Technical Memorandum

Date: February 27, 2023 Memo No.: 01
Project Name: Hunter Farm Development Project No.: LON-21008138-A0
Written By: Hagit Blumenthal, Cassandra Wallace
Subject: UTRCA Comment Response
To: Dan Vucetic (Stantec)
Stephen Stapleton (Auburn)
Distribution: email

EXP Services Inc. (EXP) is providing this memo which summarizes the hydrogeological assessment and water balance comments received from the Upper Thames River Conservation Authority (UTRCA) in their letter dated January 20, 2023. The subject site is the Hunter Farm Development located at 1598 Richmond Street (Parts of Lots 9&10 Concession 4) in the Municipality of Thames Centre (File No. 39T-TC2202 & Z17-22).

CLIENT Auburn Developments Inc.		
TITLE Drainage Catchments		
DRAWN BY: K.D.	REVIEWED BY: H.B.	DATE JUNE 2022
		EXP Services Inc. 15701 Robin's Hill Road London, ON, N5V 0A5
SCALE 1:3000	PROJECT NO. LON-21008138-A0	DWG. 16

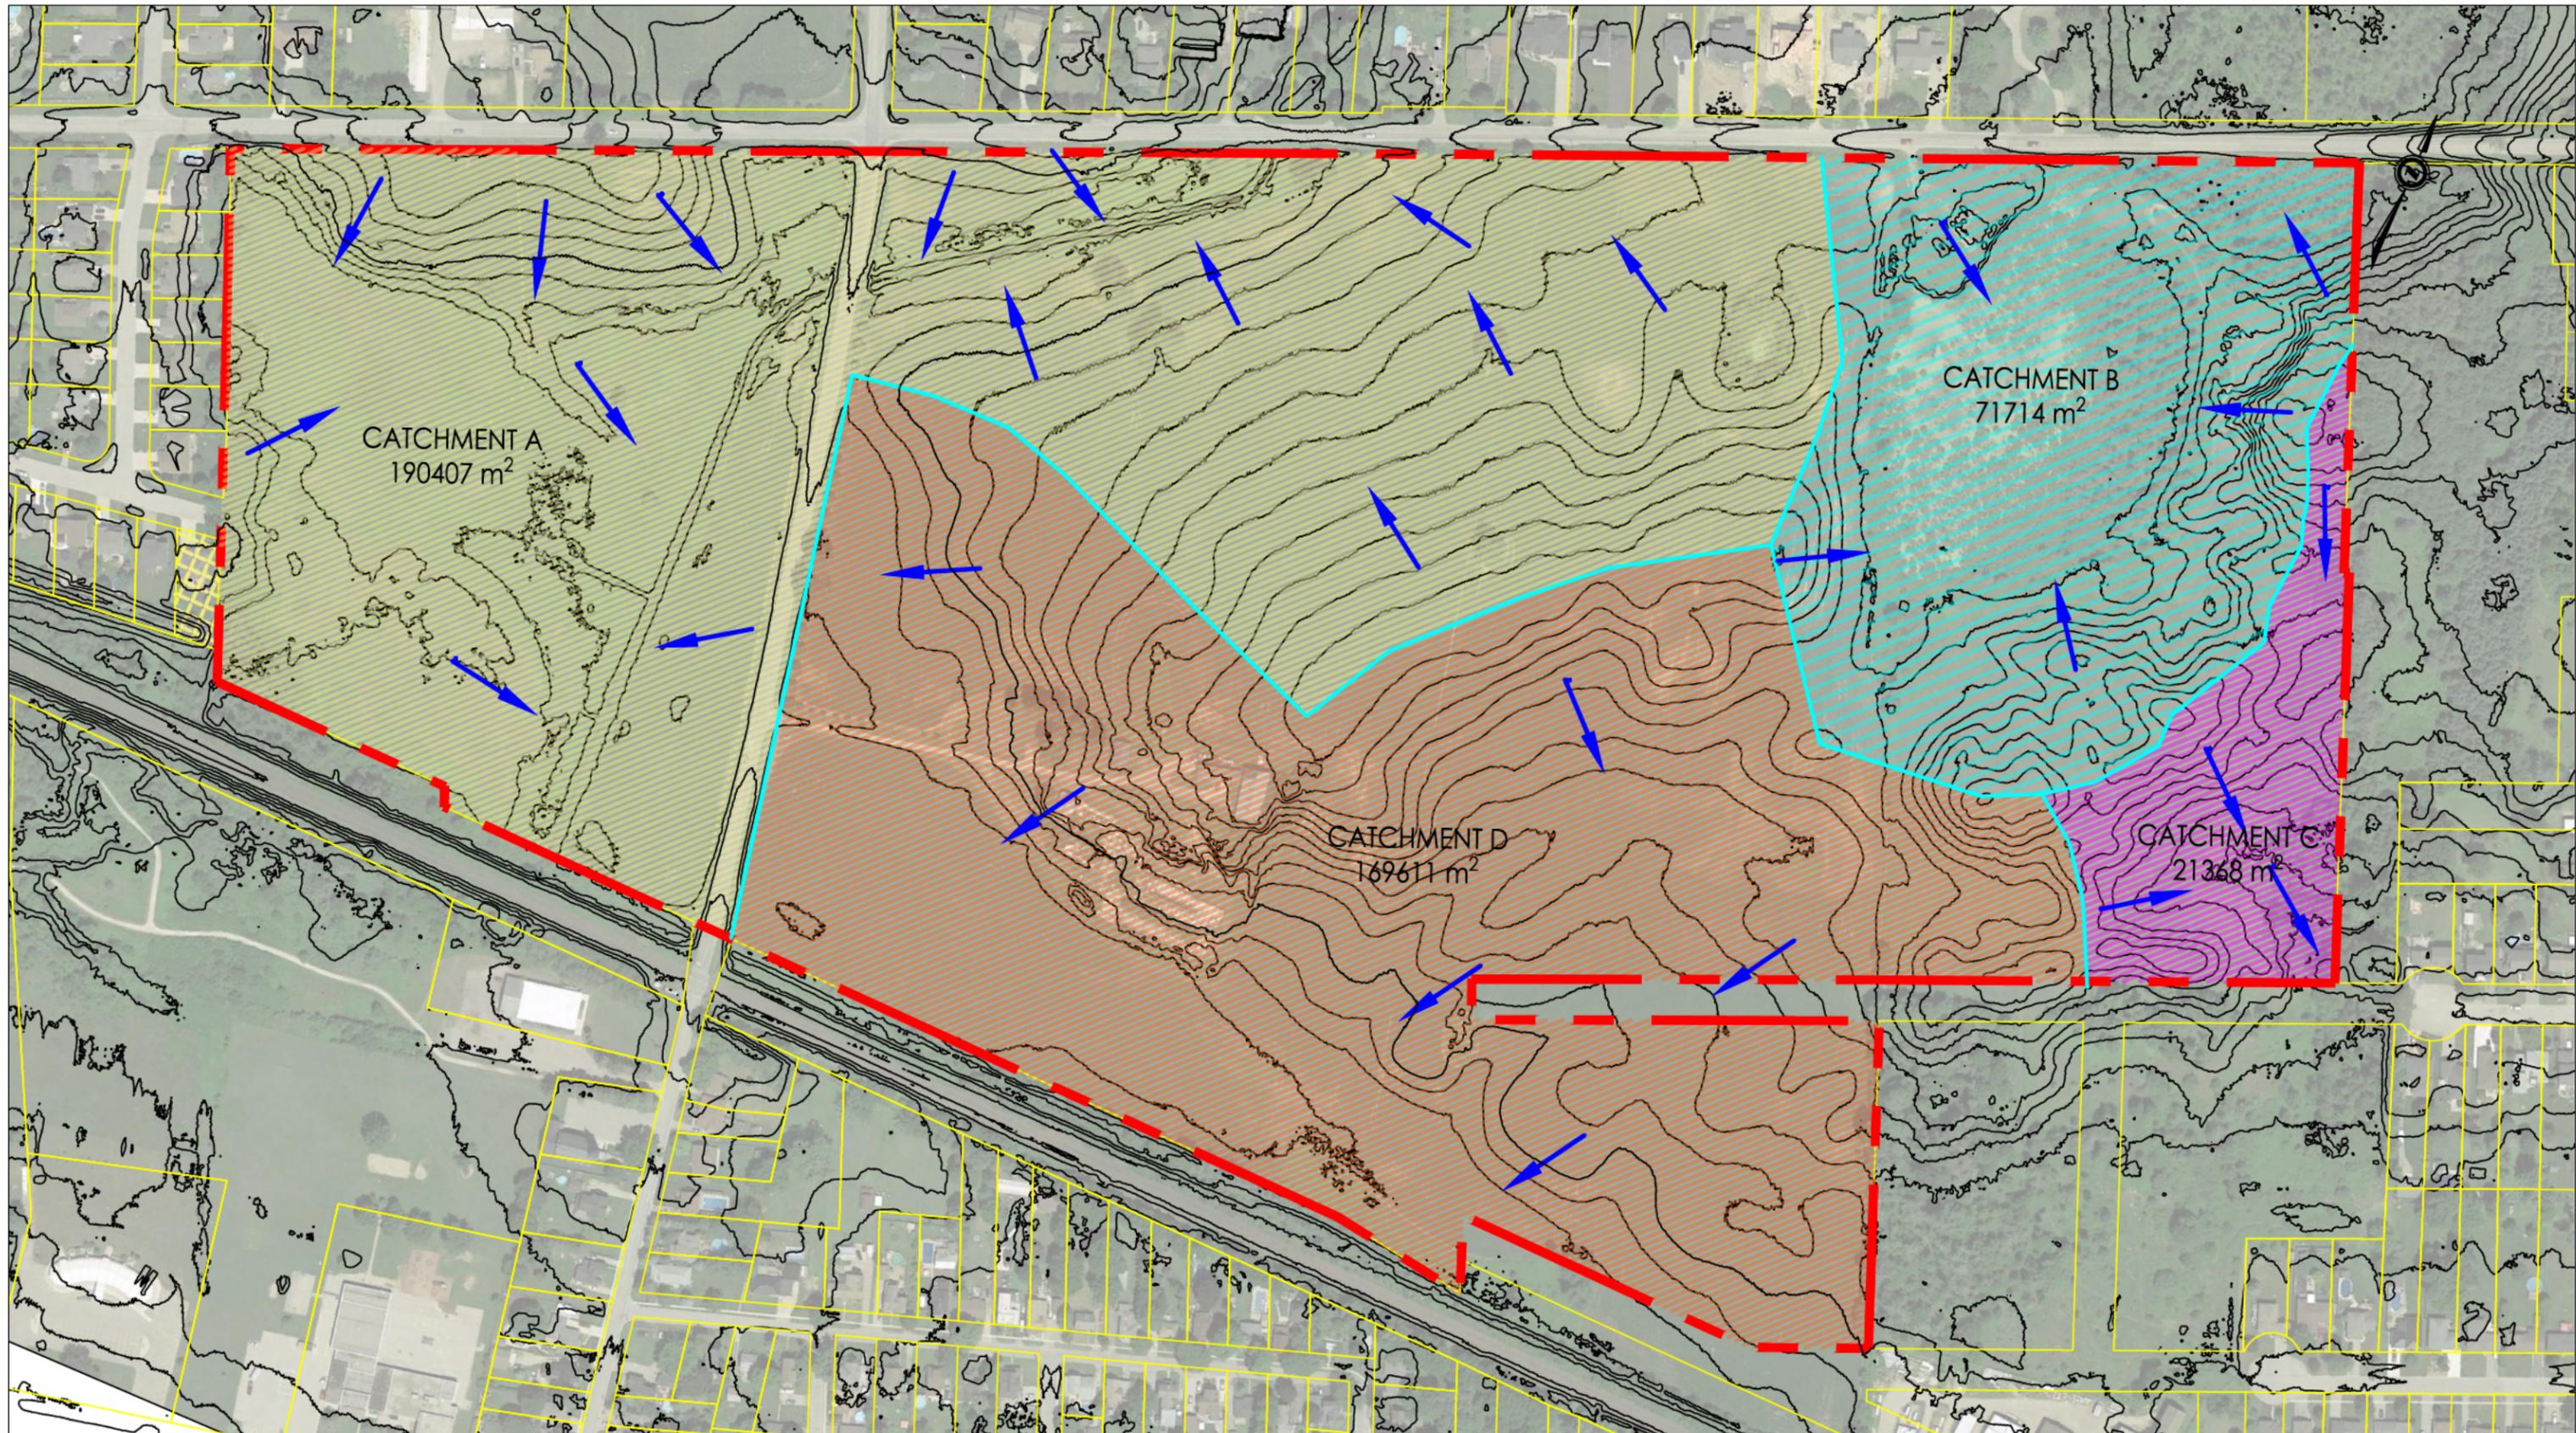
The drainage areas identified on Figure 2, Existing Storm Drainage Area Figure, of the SWM Report, does not match with the areas shown on Drawing 16, Drainage Catchments of the Hydrogeological Assessment. Please make sure that the drainage areas are correct and the areas contributing to the wetland features are identified correctly.

In conjunction with the Focused Design Studies submission, the Owner shall have his consulting engineer prepare and submit a Storm/Drainage and SWM Servicing Functional Report or a SWM Servicing Letter/Report of Confirmation to address the following:

- Identifying the storm/drainage and SWM servicing works for the subject and external lands and how the interim drainage from external lands will be managed, all to the satisfaction of the Municipality.
